UNITED STATES PATENT AND TRADEMARK OFFICE

10/775,715

Roy Gary Black

DETAILED ACTION

Figure 2 of Allen (US 6041566)

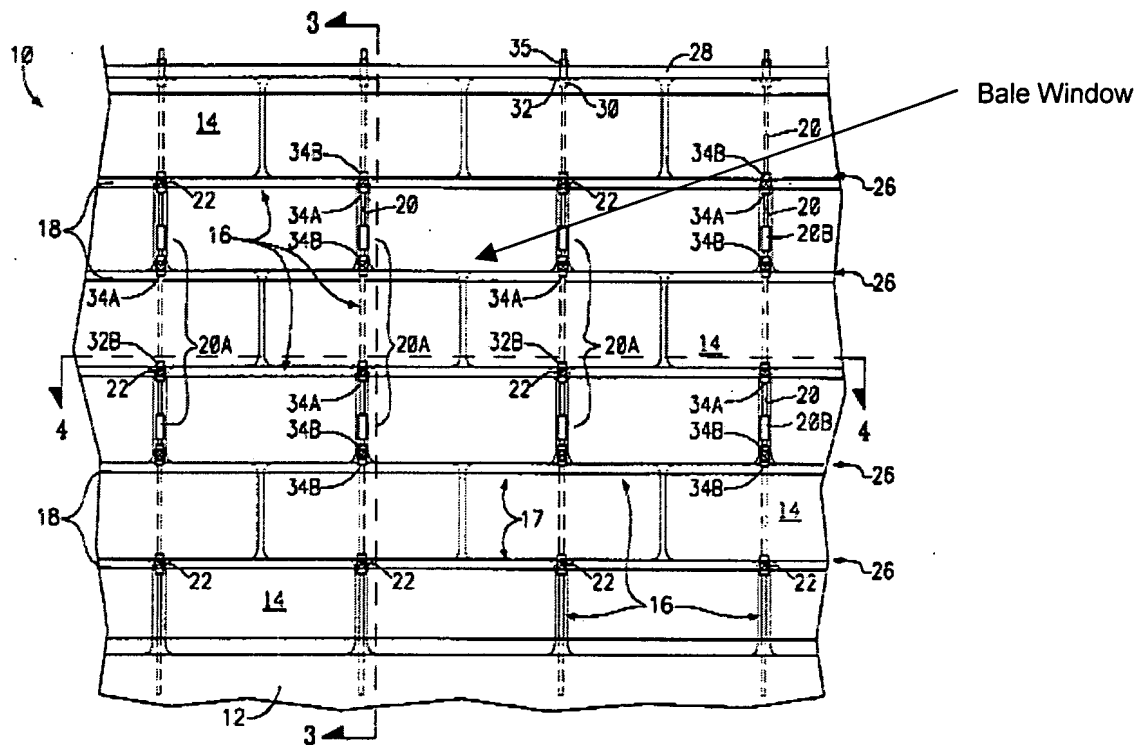
Claims 1-4, 6-11, 13-14, and 16 are rejected under 35 U.S.C. 102(b) as being anticipated by Allen (US 6041566). Allen illustrates in Figures 2 and 4, an internal bracing system (10) for a vertical wall having straw bales (14) stacked in courses on a foundation wall (12) comprising:

- A plurality of spaced apart bracing ladders (26) and mid-wall ladders extending from corner to corner (Claim 7) attached to the foundation (12) and rising vertically where some bales abut the ladders and some surround the ladders;
- Ladders with bale windows large enough to surround the bale (14);
- Ladders with alternating bale abutments (20A) between ladder windows;

- Ladders with two spaced-apart rails (24) connected by struts (20), which define a space large enough to surround a bale (Claim 10);
- A foundation (12) with spaced-apart ladders attached to it;
- X-shaped spars (24) (Claim 11);
- A stiffening ladder (18) (Claims 13 and 14).

The examiner notes, with respect to claims 7 and 8, the orientation of walls when built is generally 90 degrees or at right angles to one another. It is assumed that the mid-wall ladders of Allen's Figure 4 would be in each wall and by definition (based on claim 8 of the application) would be corner ladders.

Claims 19-30 are rejected under 35 U.S.C. 103(a) as being unpatentable over Allen (US 6041566). Allen illustrates in Figures 2 and 4, an internal bracing system (10) for a vertical wall having straw bales (14) stacked in courses on a foundation wall (12) comprising:

- A plurality of spaced apart bracing ladders (26) and mid-wall ladders attached to the foundation (12) and rising vertically where some bales abut the ladders and some surround the ladders;
- Ladders with bale windows large enough to surround the bale (14);
- Ladders with alternating bale abutments (20A) between ladder windows;
- Ladders with two spaced-apart rails (24) connected by struts (20), which define a space large enough to surround a bale;
- A foundation (12) with spaced-apart and corner (Column 7, lines 6-8) ladders attached to it;
- Spars (34A and 34B) at the end of bales in running bond (Column 2, lines 25-28). The examiner notes that the spars are not shaped like an hourglass, however the shape does not add any additional structure or alter the function of the apparatus;
- A stiffening ladder (18, 26) either at the top of the sixth, or top, course.

Figure 16 of Allen (US 5749199)

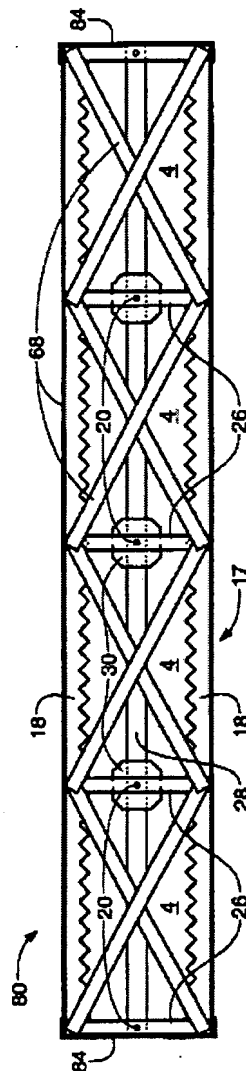
Claims 15 is rejected under 35th U.S.C. 102(b) as being anticipated by Allen (US 5749199). Allen discloses in the specification and illustrates in Figures 10 and 16 a straw bale wall with an internal bracing system comprising:

- A foundation wall (12) with a plurality of anchor dowels (dotted rectangles in Figure 10 within the foundation (12));
- Mid-wall bracing ladders (26) affixed to the foundation (12) via anchor dowels (28);

- Straw bales (4) stacked on the foundation (12) in a running bond (Column 2, lines 51-54), with some abutting bracing ladders and others surrounded by the bracing ladders.

the anchor dowel to the top of the bale stack. However, Allen (US 5749199) illustrates in Figure 16 (see Figure above) anchor dowels (dotted rectangles in Figure 10 within the foundation (12)) affixed to the foundation wall (12) and connecting rods (28) extending vertically from the anchor dowel to the top of the bale stack. It would have been obvious to one of ordinary skill in the art, with the motivation of stabilizing the straw bales within the wall to be able to withstand strong storms and normal movement within the structure, to modify the straw bale core wall of Allen (US 6041566) with the anchoring dowels and connecting rods of Allen (US 5749199).
